Richland Parks and Recreation Building | City of Richland  
WBA Project No. 2619

## ADDENDUM NO. 01

Encl:    Drawings (24x36):  
          E1.3 SOCCER FIELDS

**Lighting System**

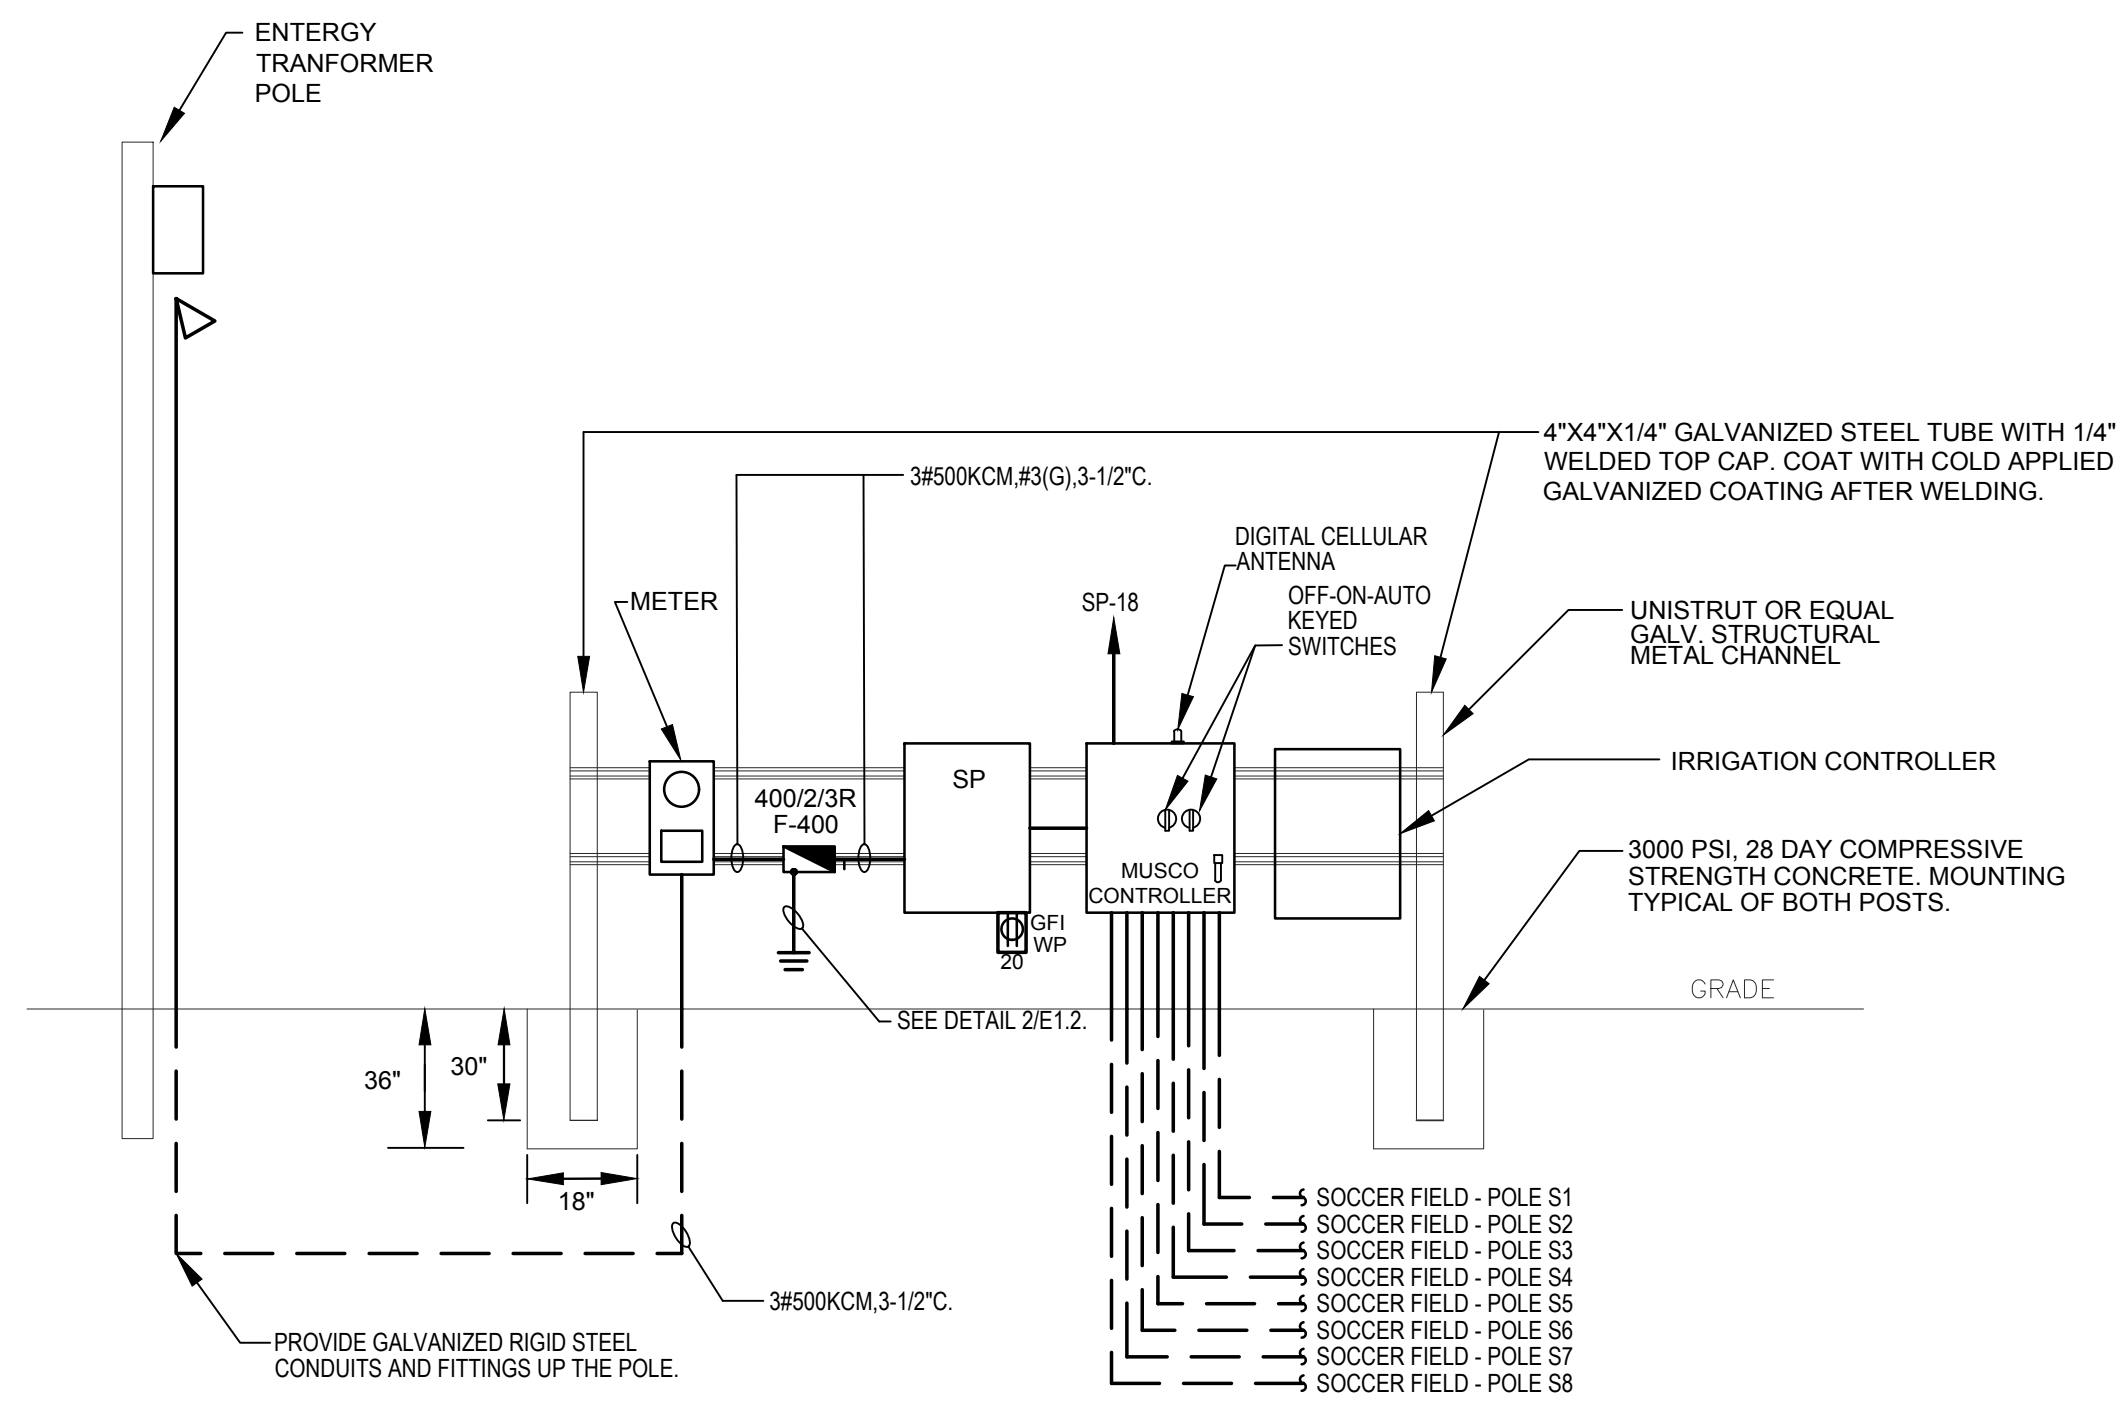
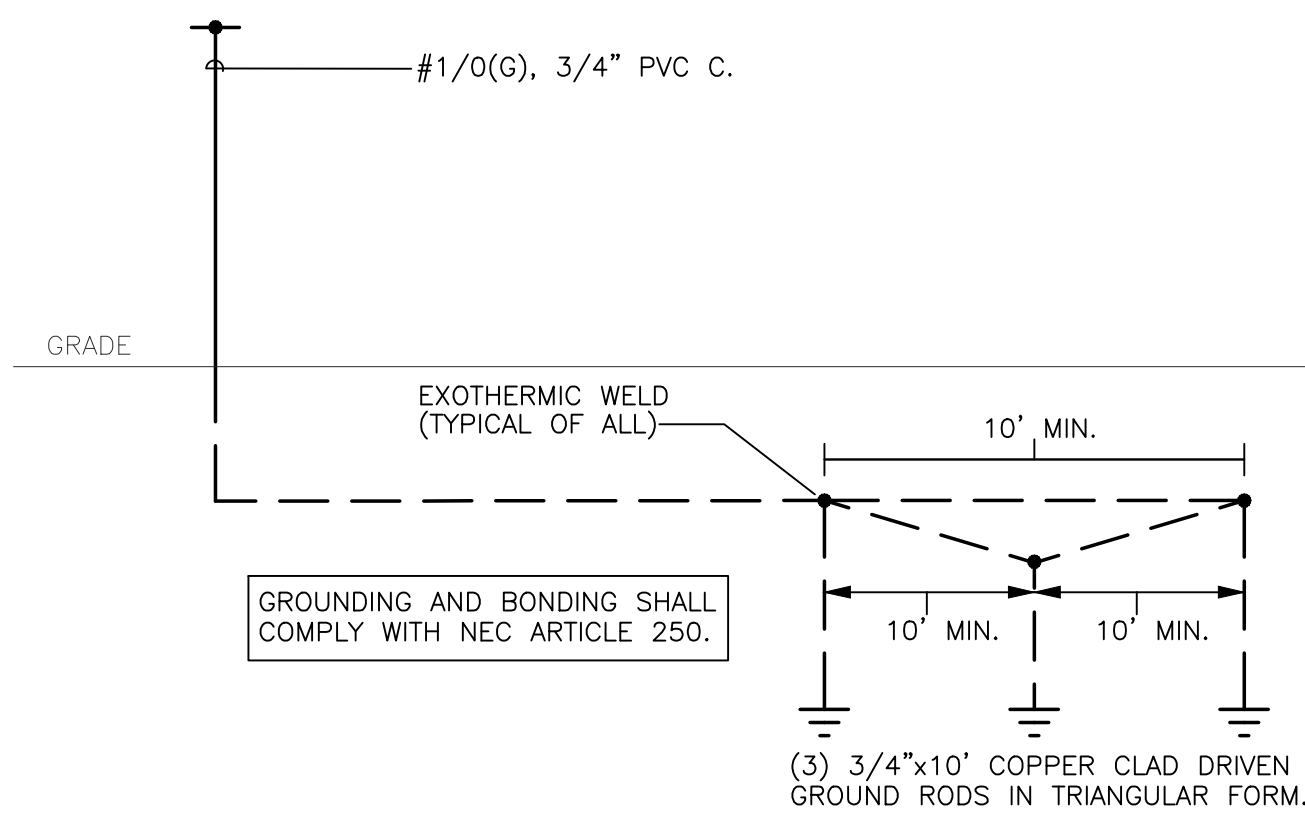
- ITEM NO. 03**      **SHEET E1.3 SOCCER FIELDS**  
**DELETE** sheet in its entirety and **REPLACE** with enclosed sheet. **ADD** lighting system notes.
